KIAWAH RIVER PLANTATION (KRP) WASTEWATER TREATMENT PLANT (WWTP)

T&H PROJECT NO.
J-25328

ADDENDUM NO. 3

March 24, 2016

Drawing No.
35-A-18

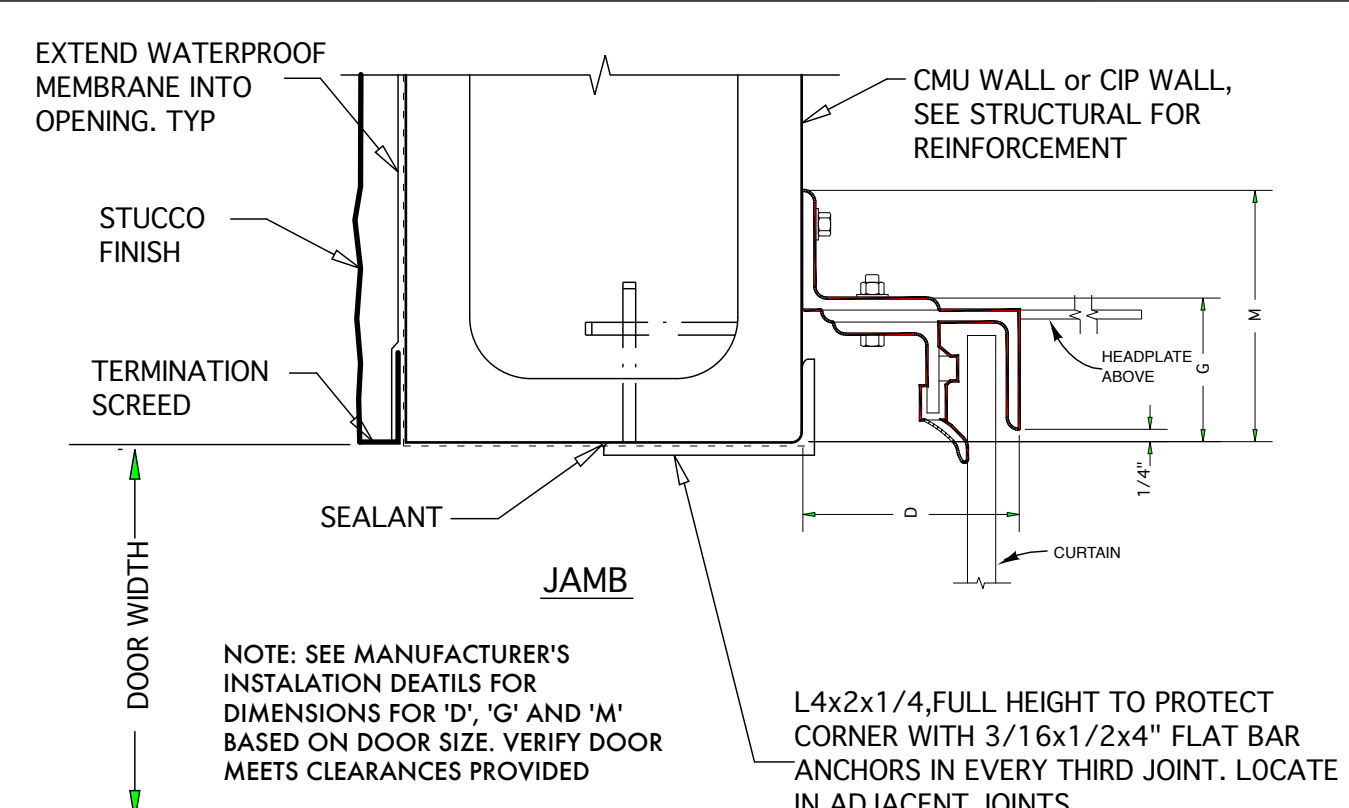
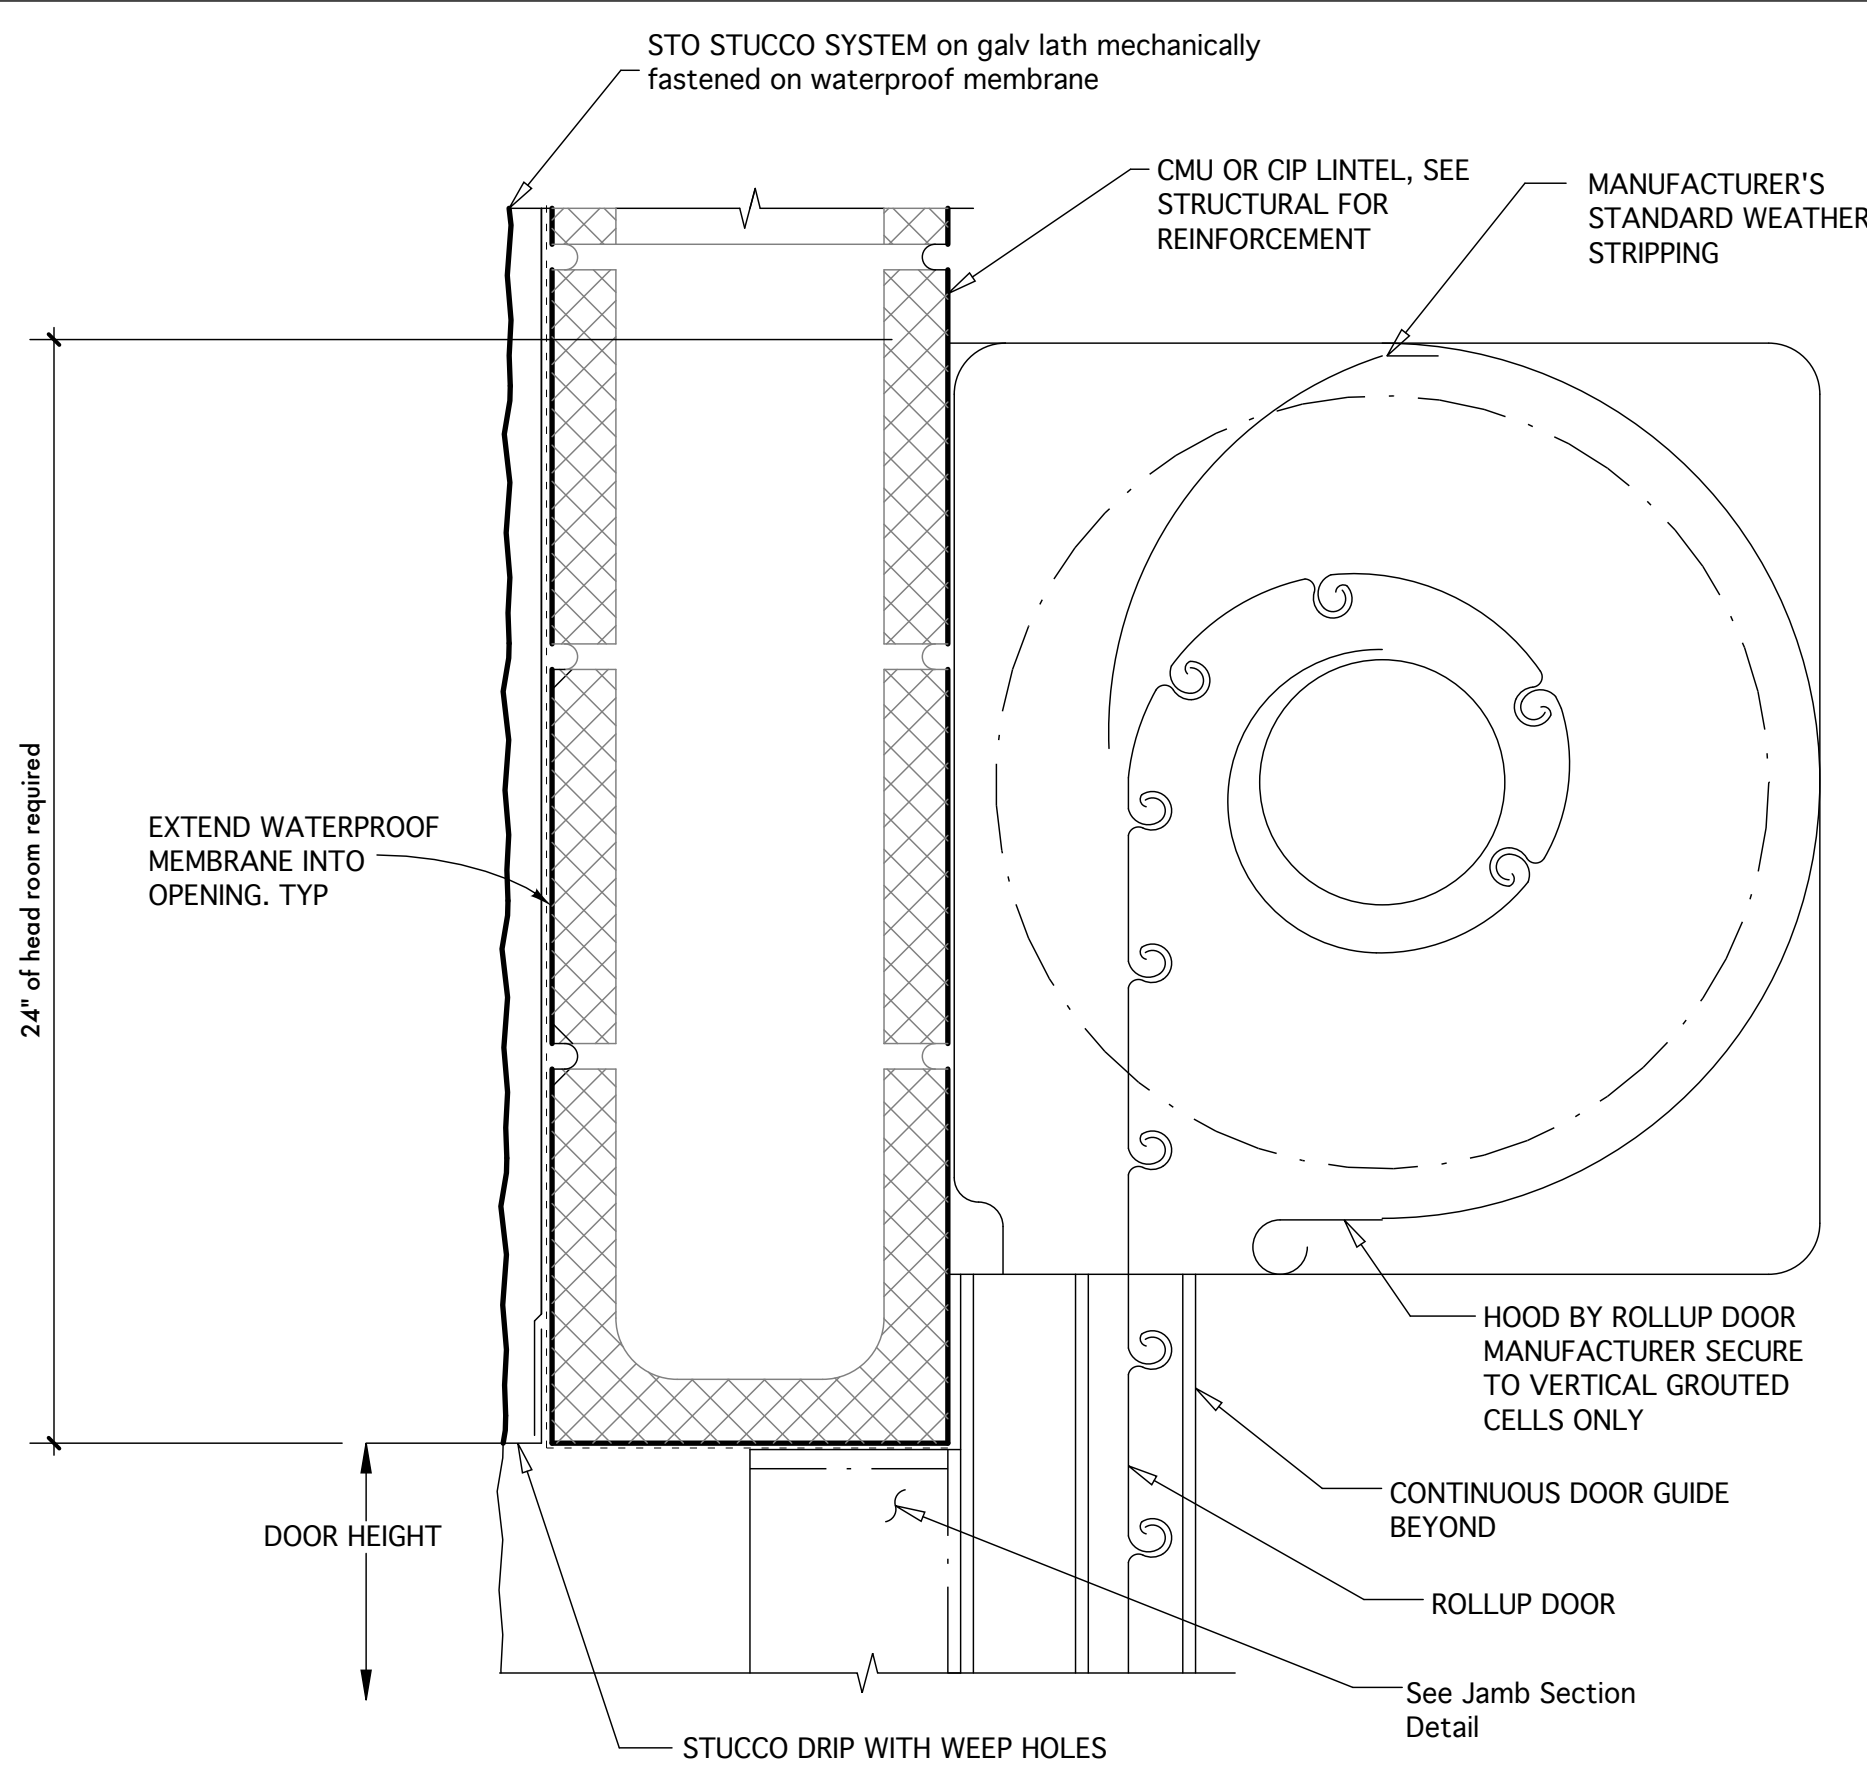
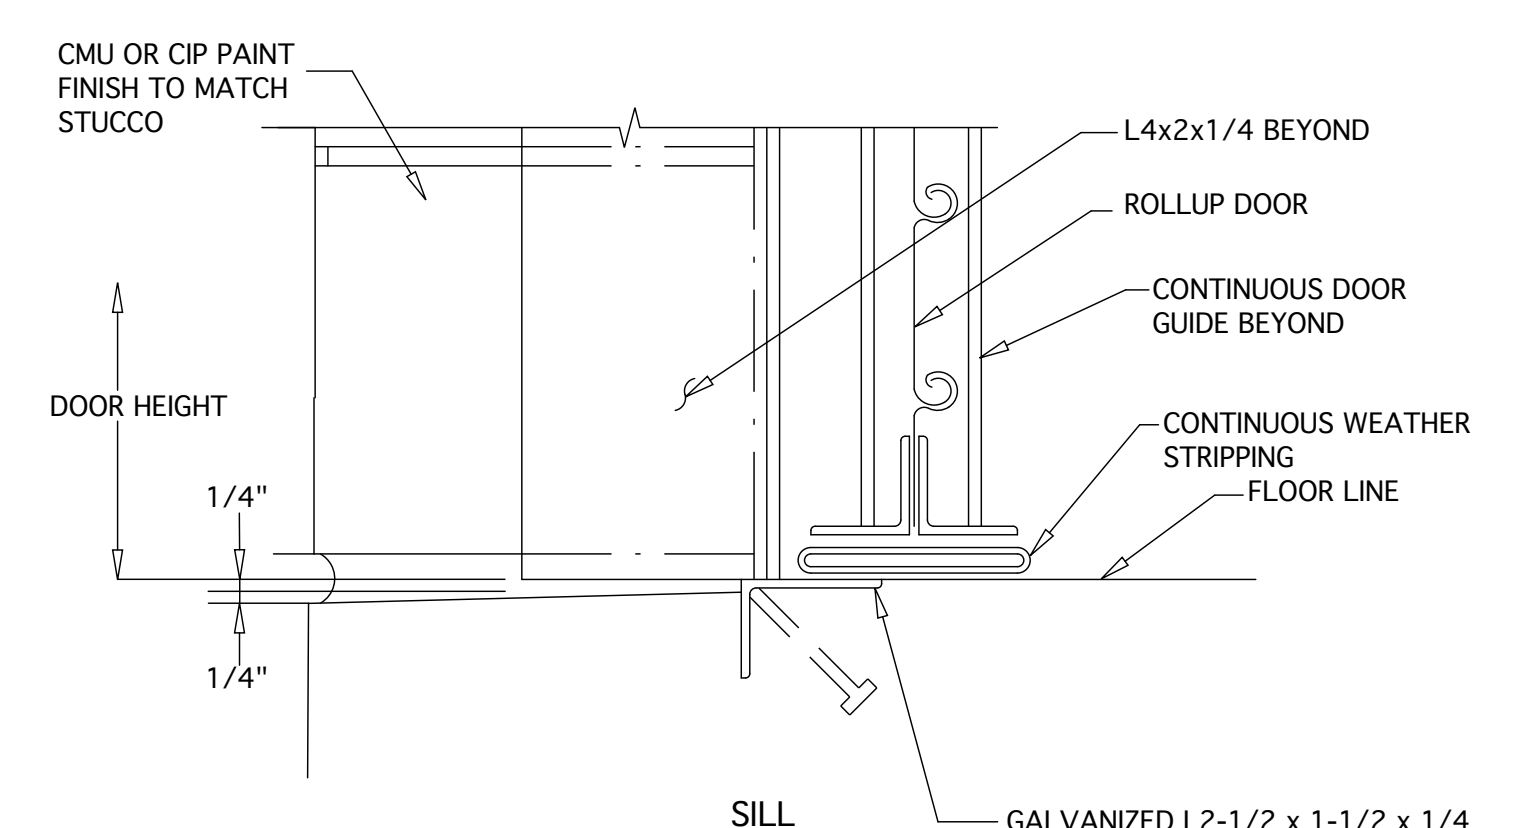
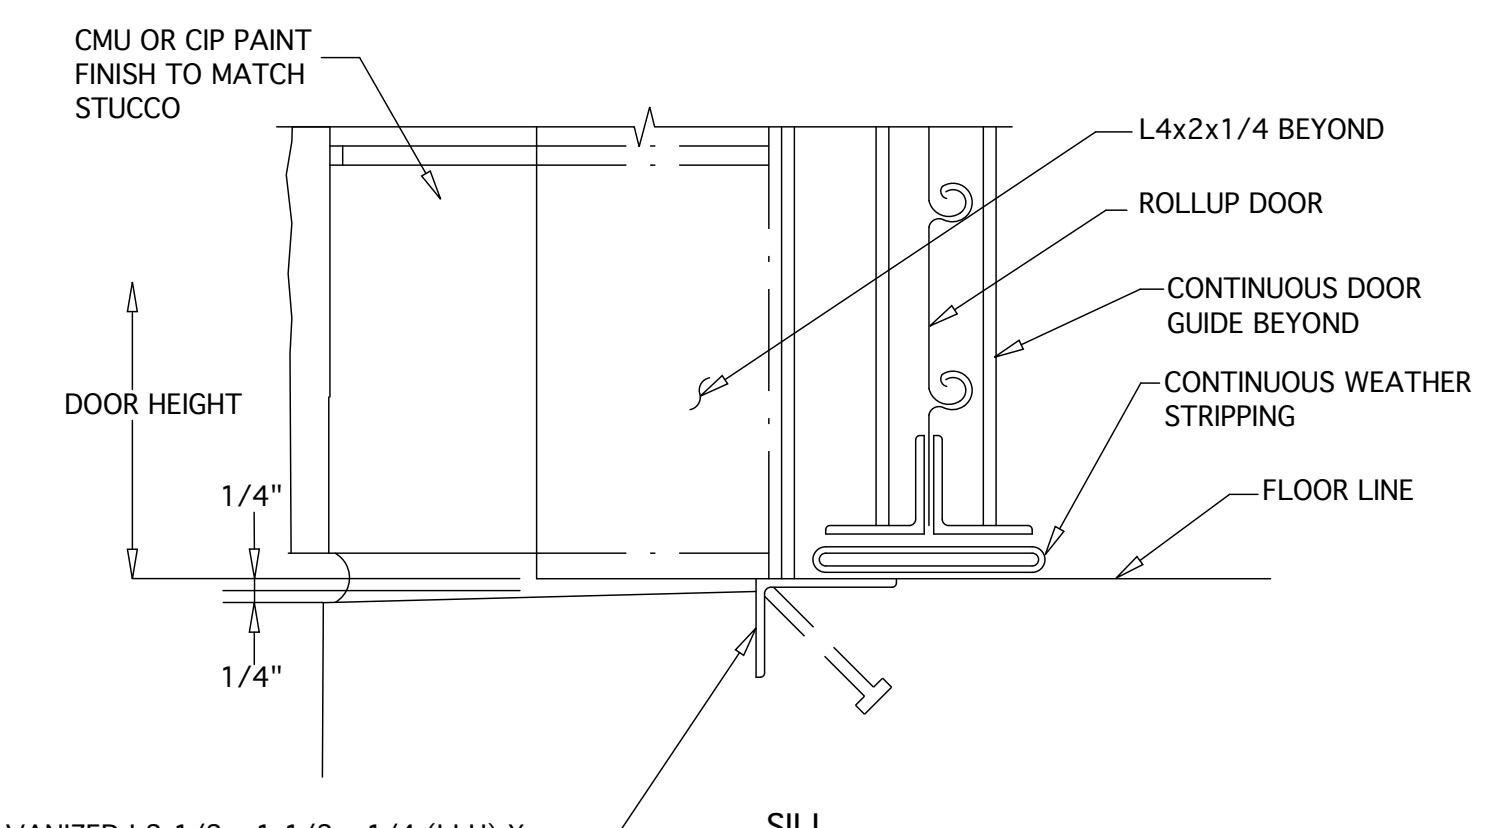
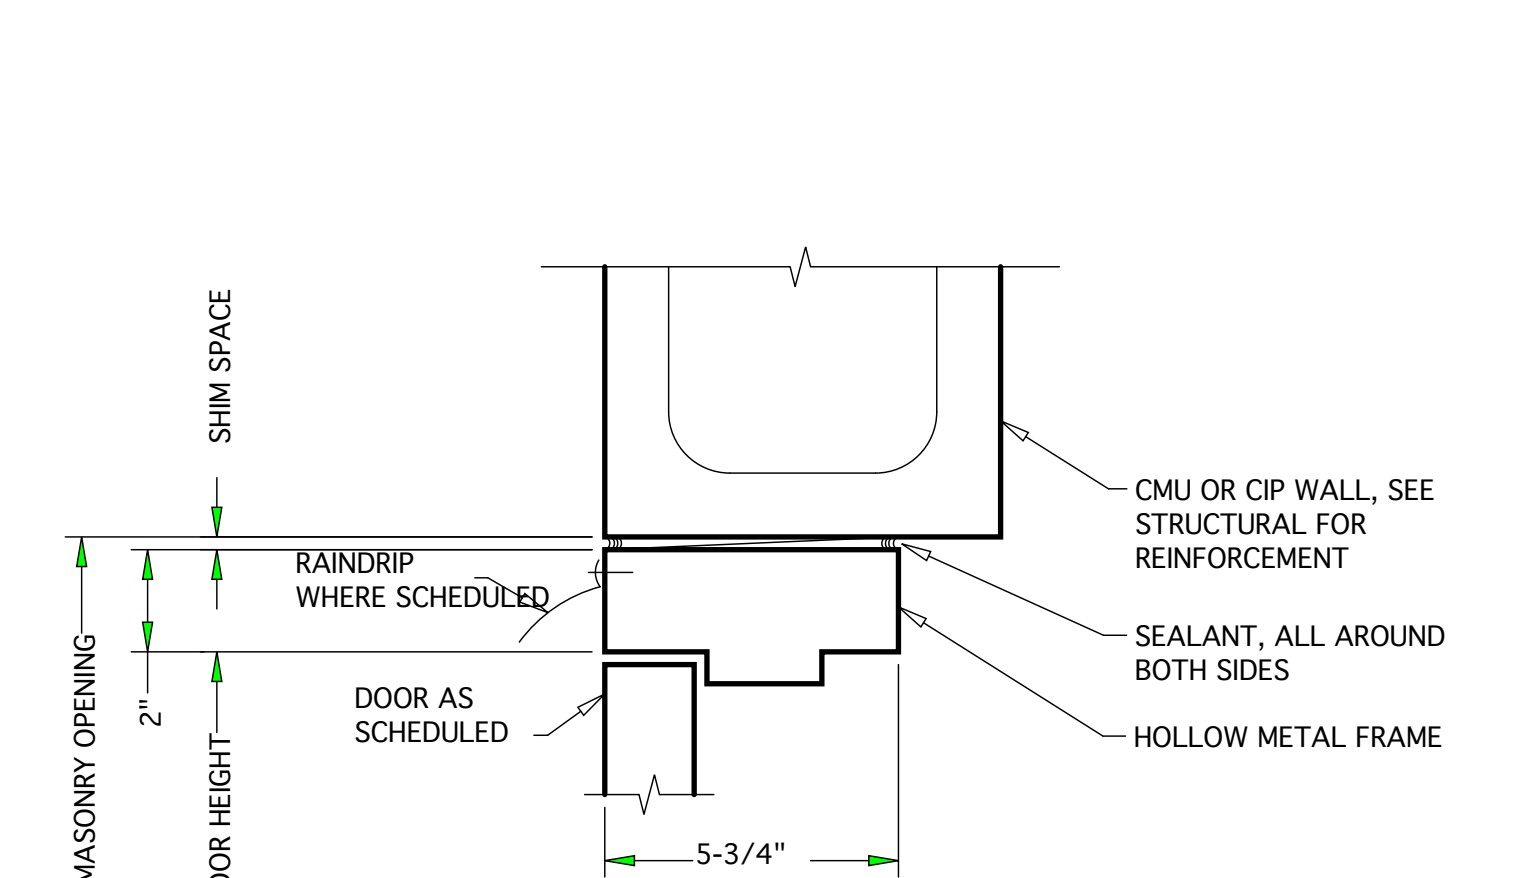
2. Drawings 35-A-18 and 35-A-19 include details for the installation of the doors and louvers in CMU and metal stud walls. Can you provide details for doors and louvers installed in cast-in-place concrete locations (i.e. lower level of Waste Water Treatment Facility on Drawing 35-A-10)?

Answer: See Revised Sheet 35-A-18 included with this addendum.
